95 BERKELEY

SELDC | OCTOBER 1, 2024

WHAT WE HEARD

CHANDLER ST

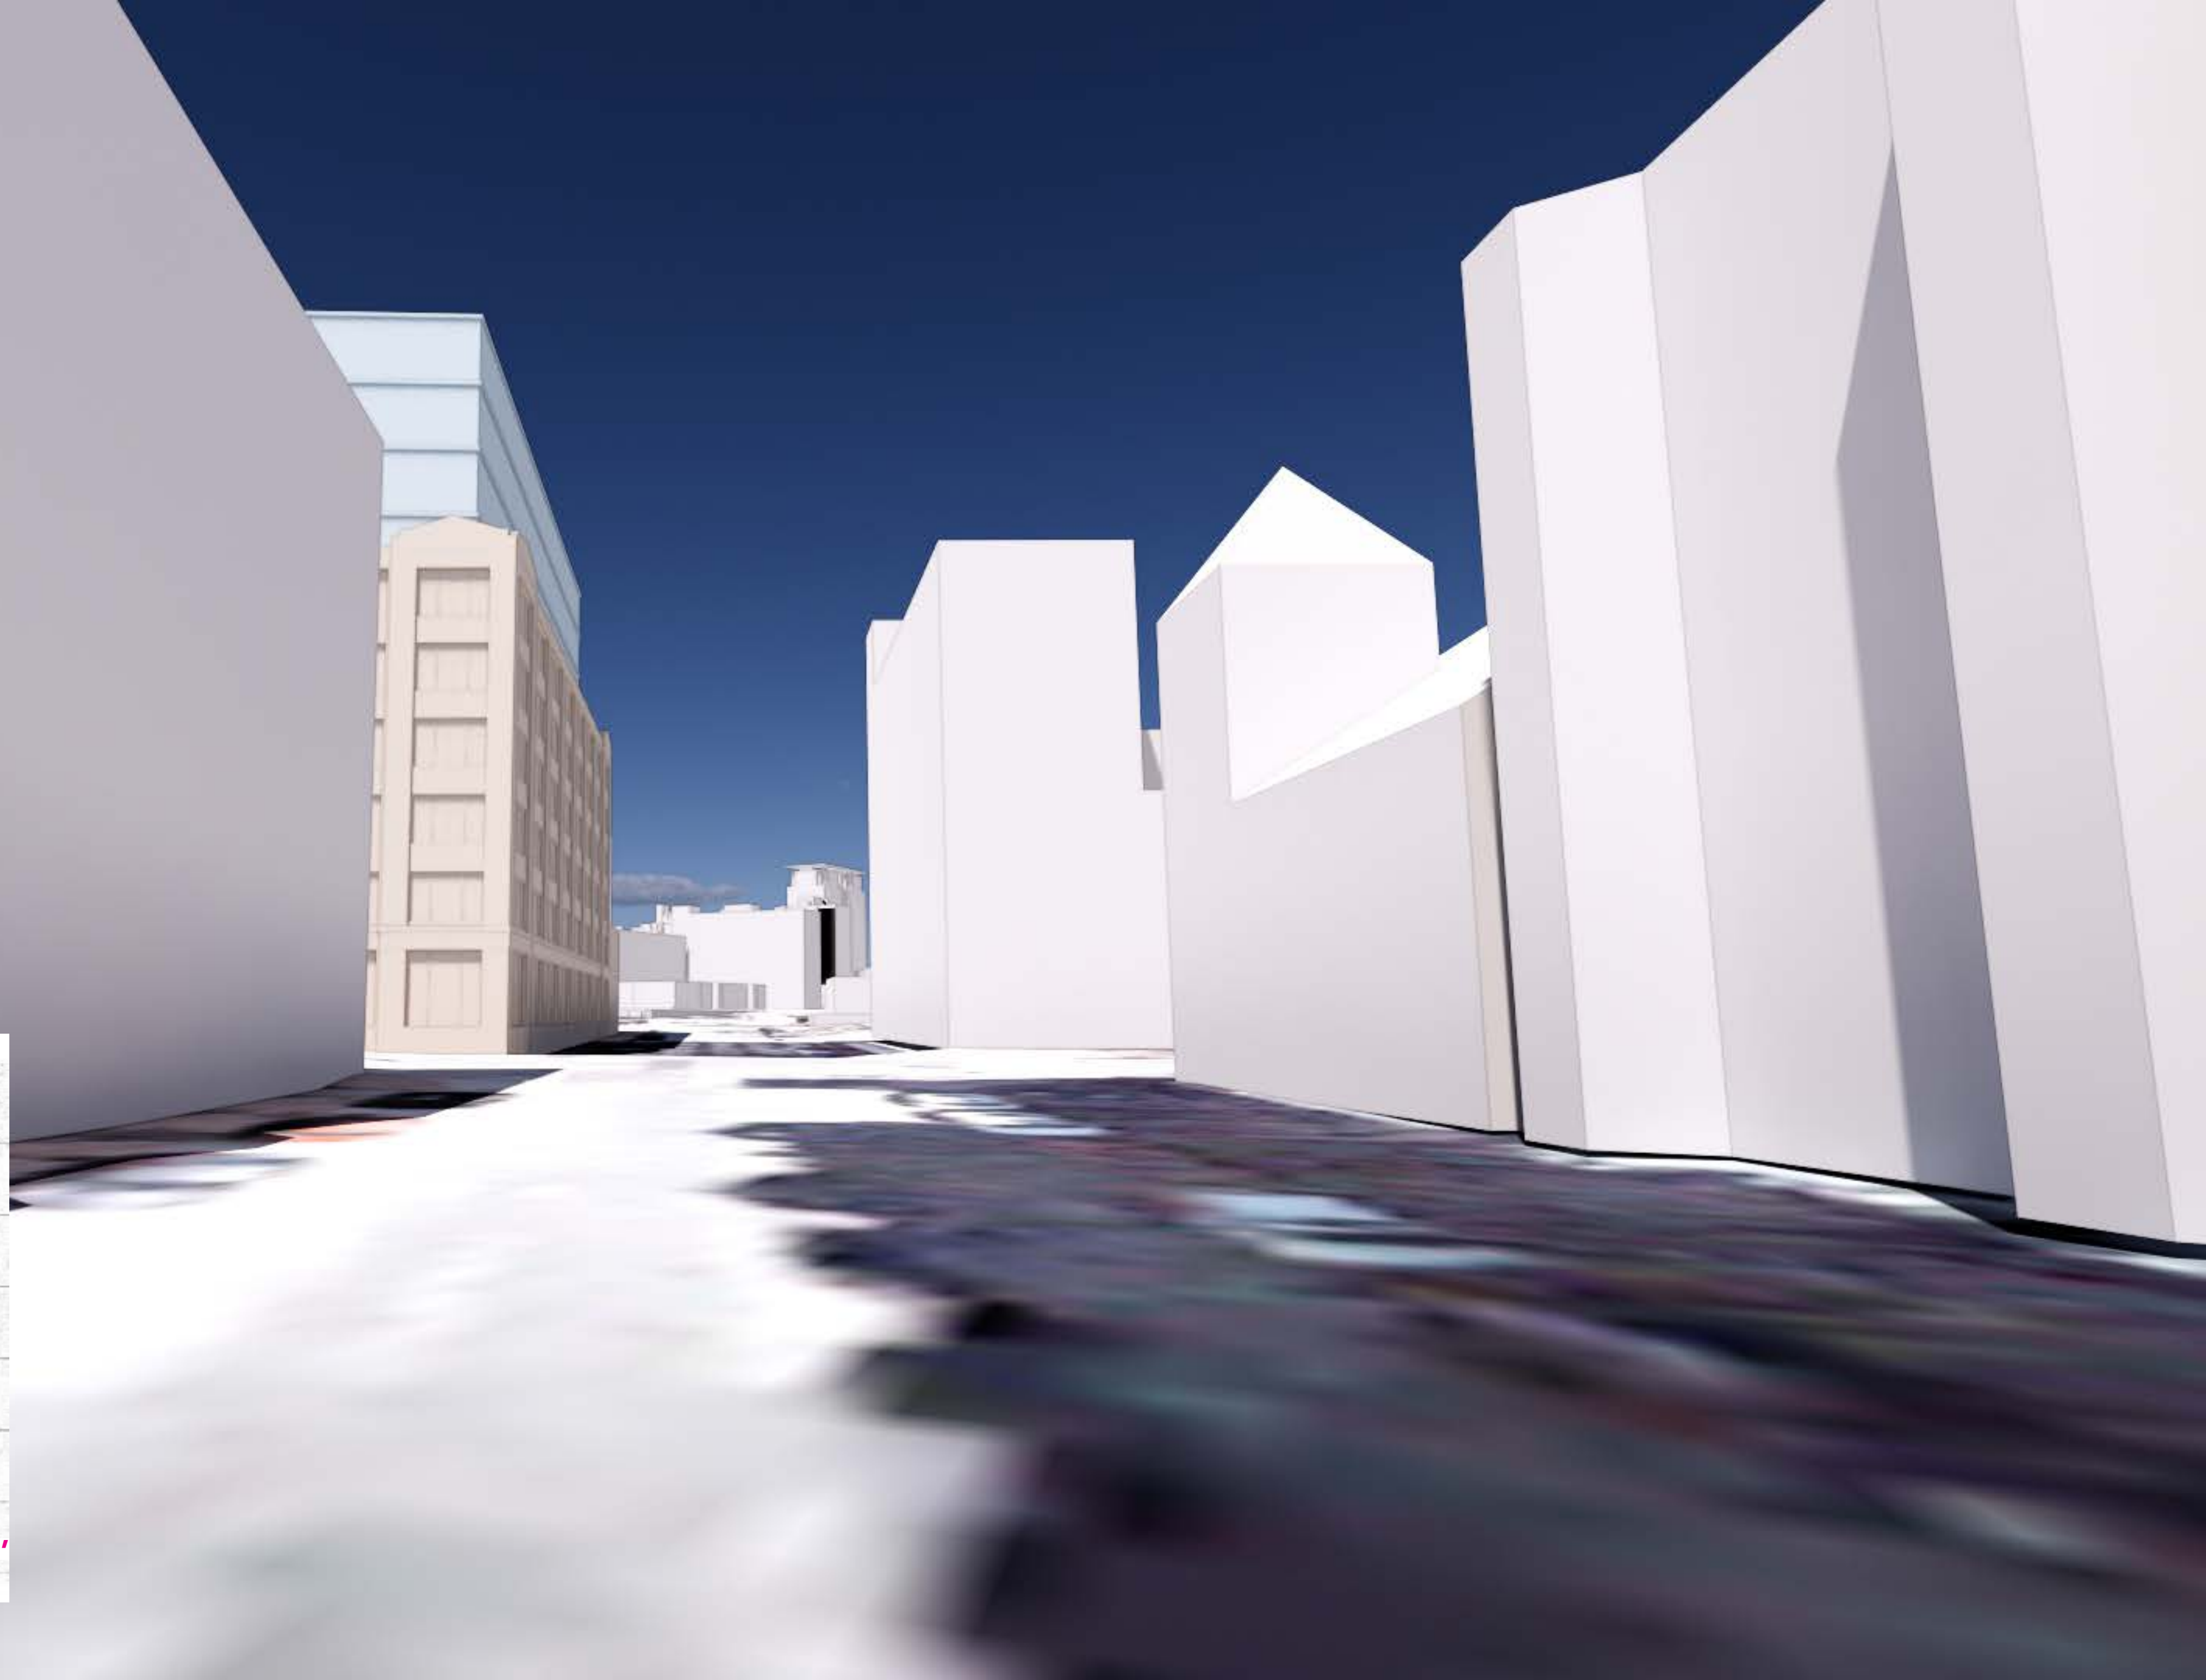
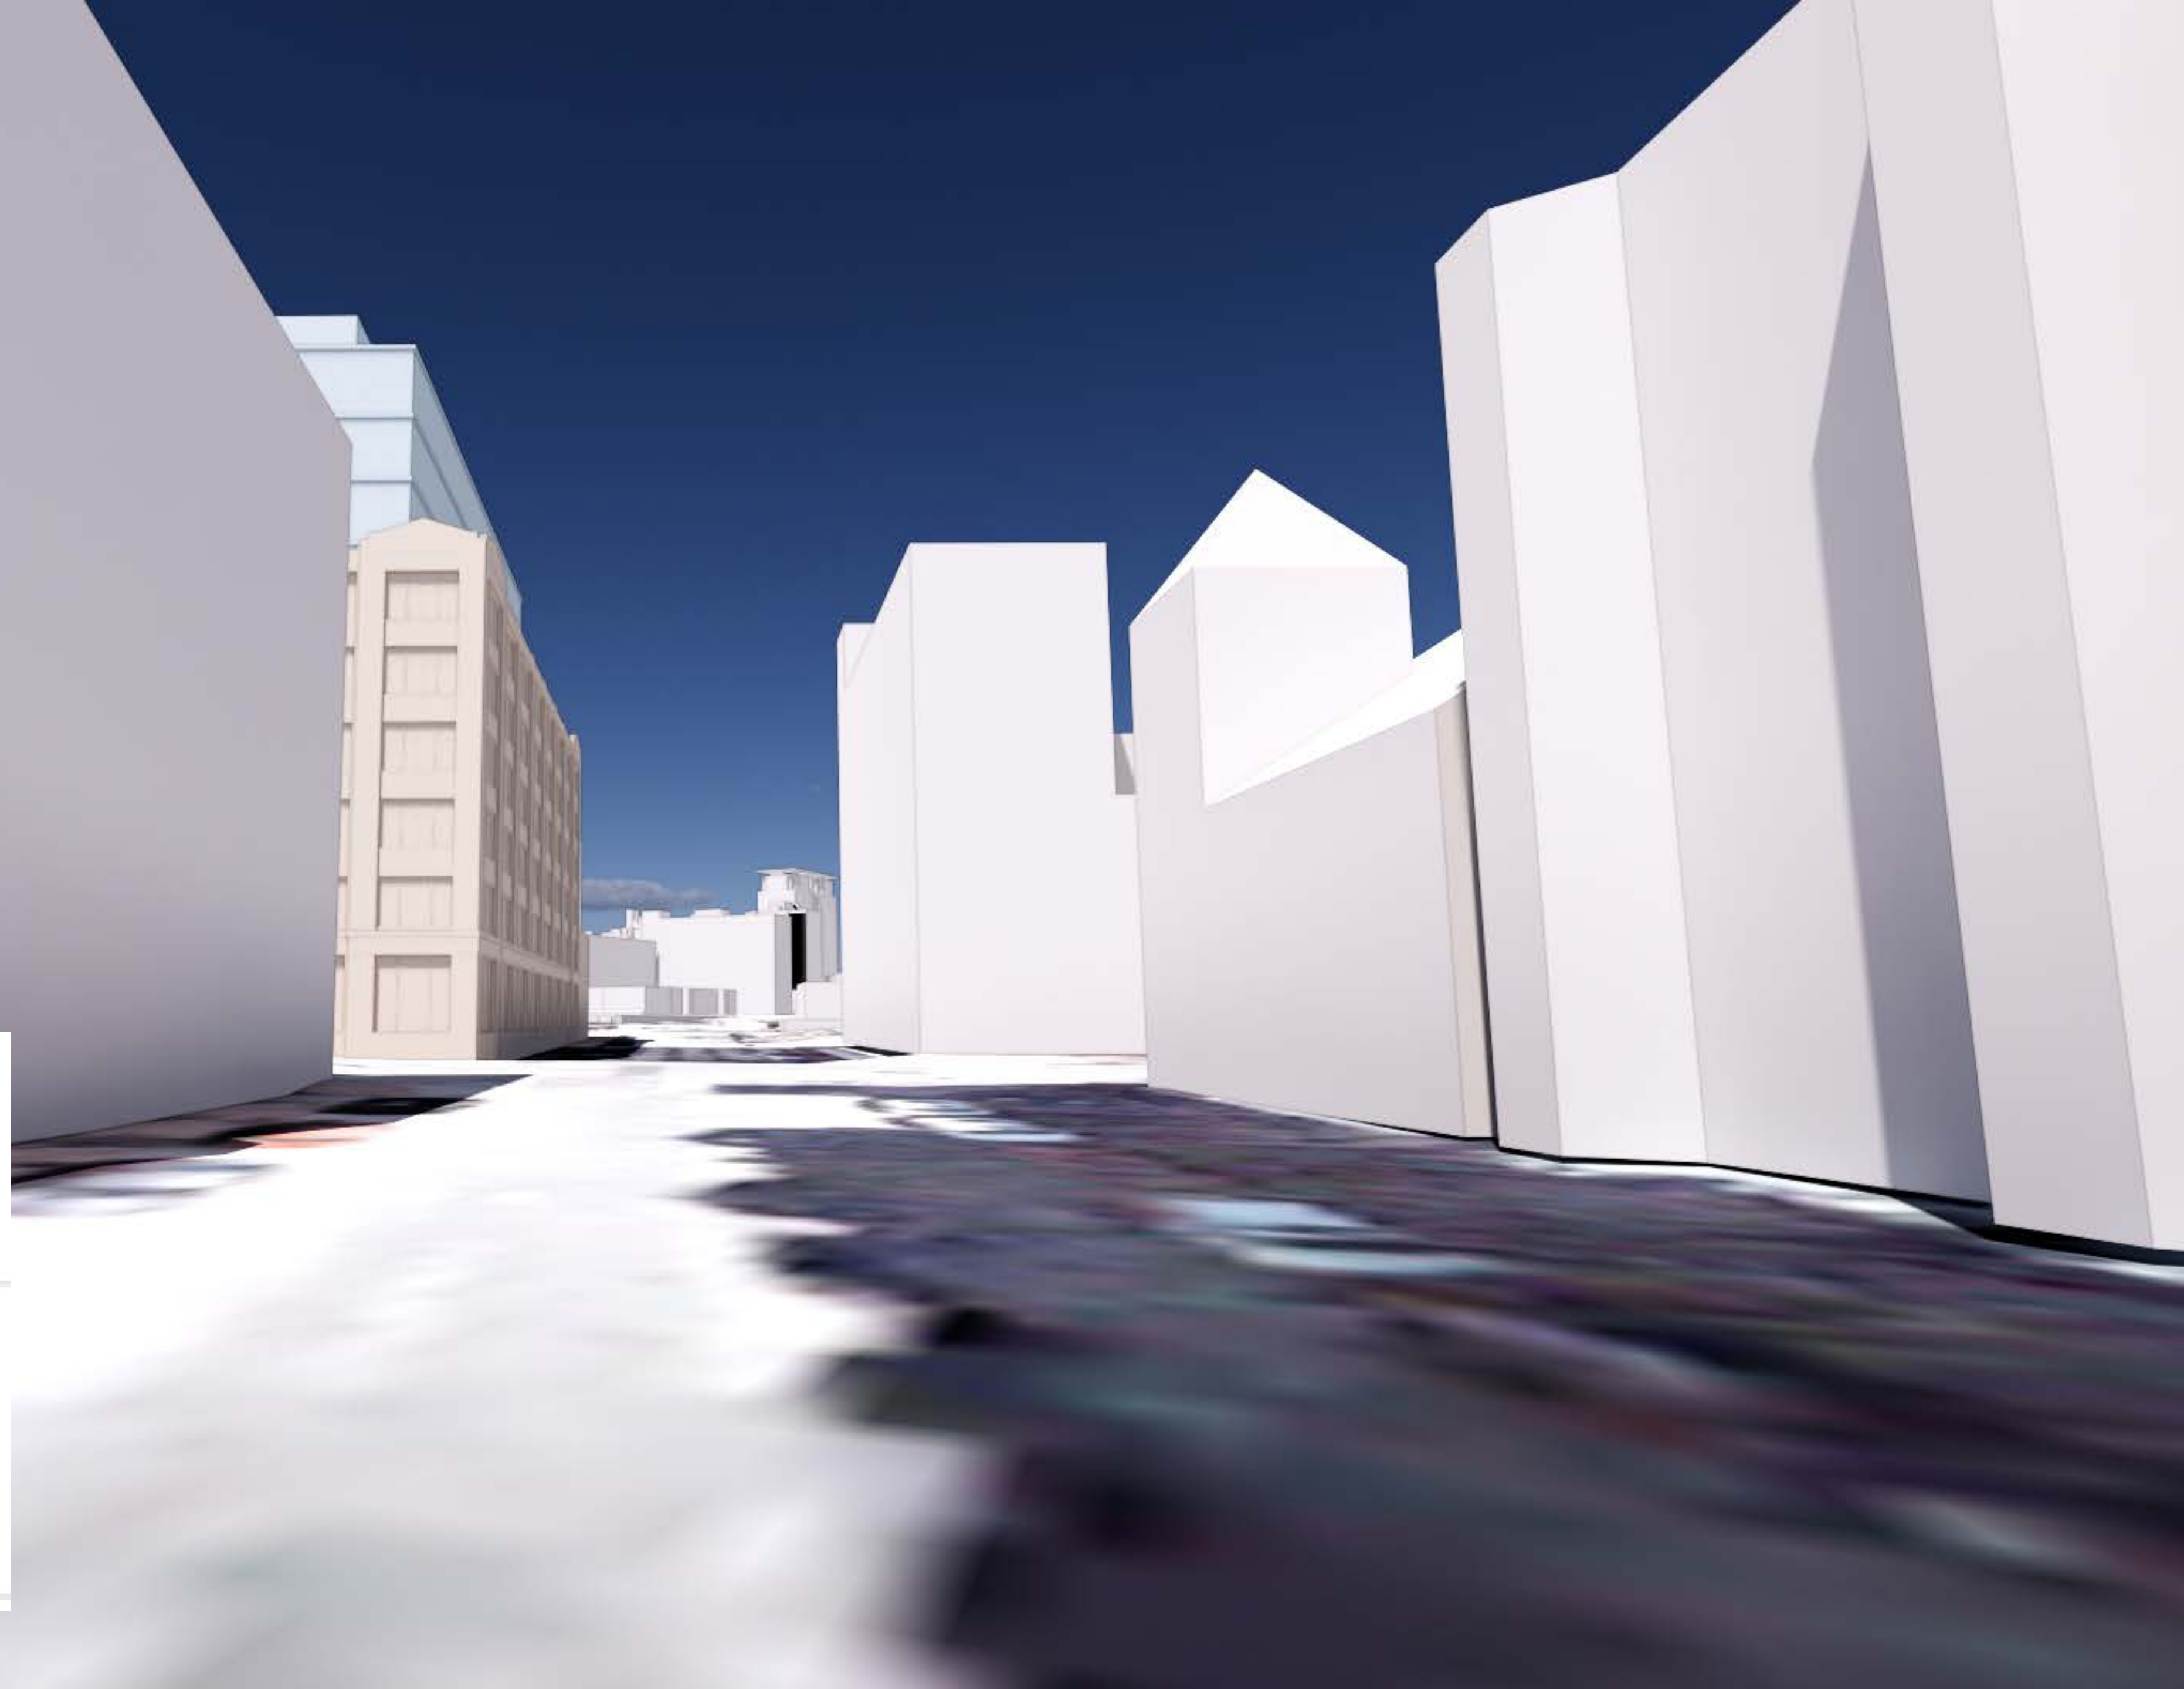
03 Reduce visual impact of addition when viewed from Chandler
